City of Tualatin

ARCHITECTURAL REVIEW DECISION

AR-18-0003

Case #:	AR-18-0003
Project:	South Lake Center
Location:	16885 SW 65th Avenue, Lake Oswego; Tax Lot 2S1 13AD 00600
Applicant/Owner:	Inspired Architecture, LLC/South Lake Center, LLC
Applicant/Rep.:	Quince Sterry, Inspired Architecture, LLC, Eugene, OR, q@qsterry.com

**REVISED
LANDSCAPE
PLAN**

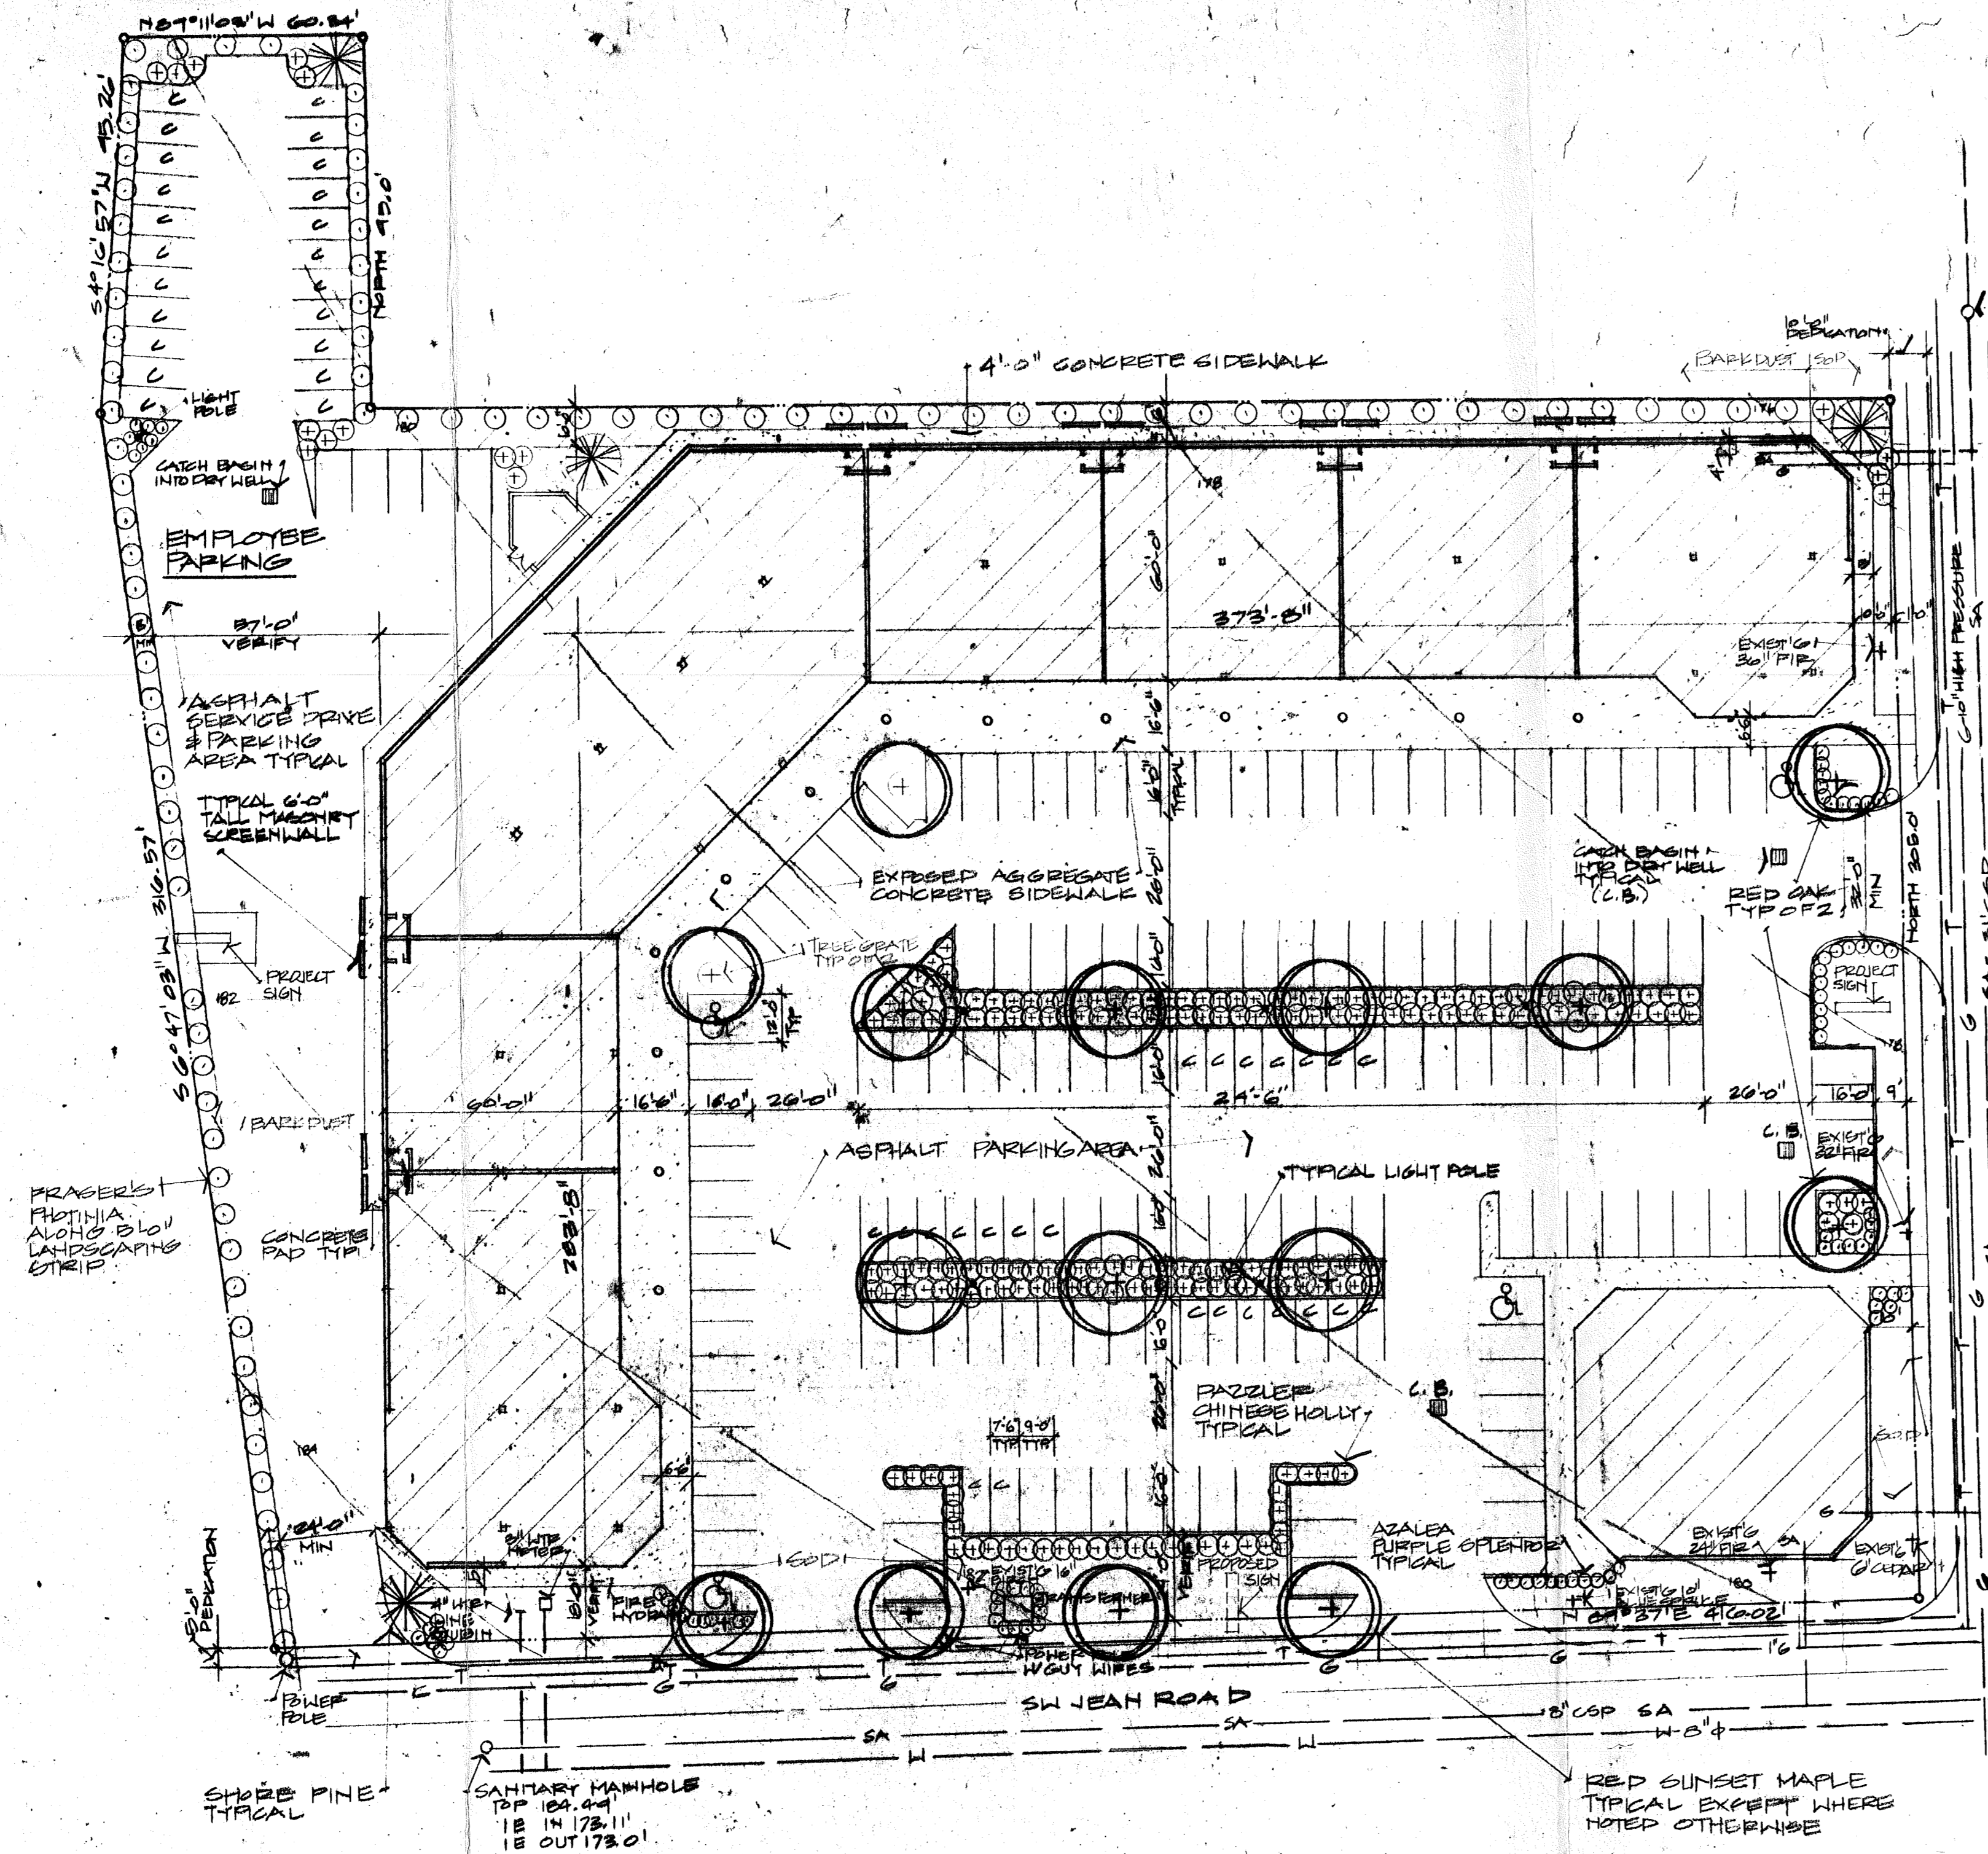
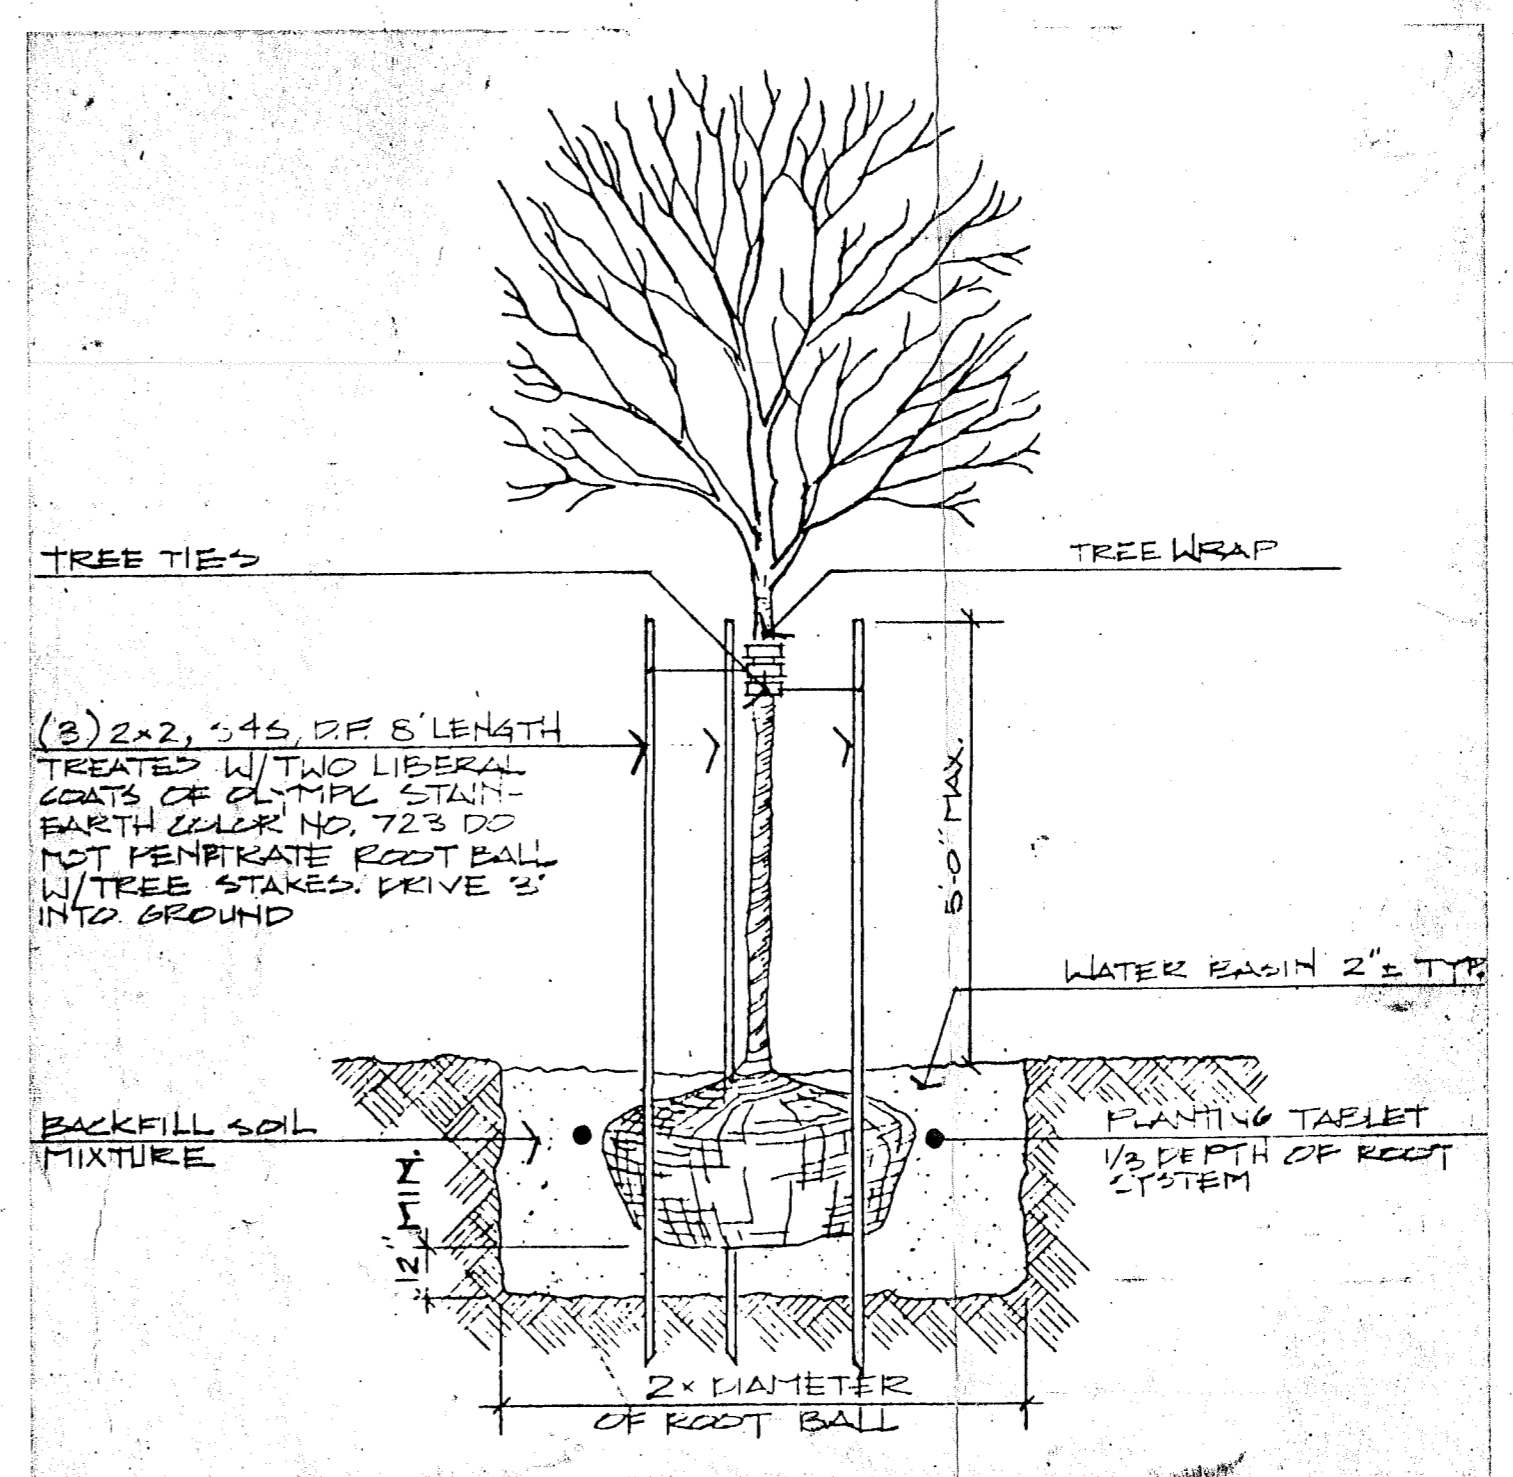
Per Condition of Approval AF-2, the applicant must landscape and maintain the western and southern yards as approved in AR85-24 (Exhibit D), pursuant to TDC 73.240(10) and 73.100(1). This includes Fraser's Photinia along the western landscape strip and three Red Sunset Maple trees along the southern landscape island. The applicant may submit an alternative landscape plan for review and landscape as approved.

- AF-2 The applicant must replace Fraser's Photinia along the western landscape strip and three Red Sunset Maple trees along the southern landscape island and continuously maintain all landscaped areas as approved in AR-85-24 (Exhibit 104), pursuant to TDC 73.240(10) and 73.100(1). Deciduous trees must be a minimum one and one-half inch (1-1/2") caliper measured six inches (6") above ground, and shrubs shall be at least one (1) to five (5) gallon size, per TDC 72.260. All trees and plant materials shall be healthy, disease-free, damage-free, well-branched stock, characteristic of the species, pursuant to TDC 73.260(4). All required landscaping must be installed in accordance with the provisions of Sunset New Western Garden Book (latest edition) or the American Nurserymen Association Standards (latest edition), pursuant to TDC 73.260(3). The applicant may submit an alternative landscape plan for review and approval by the City Manager or designee, and landscape as approved.
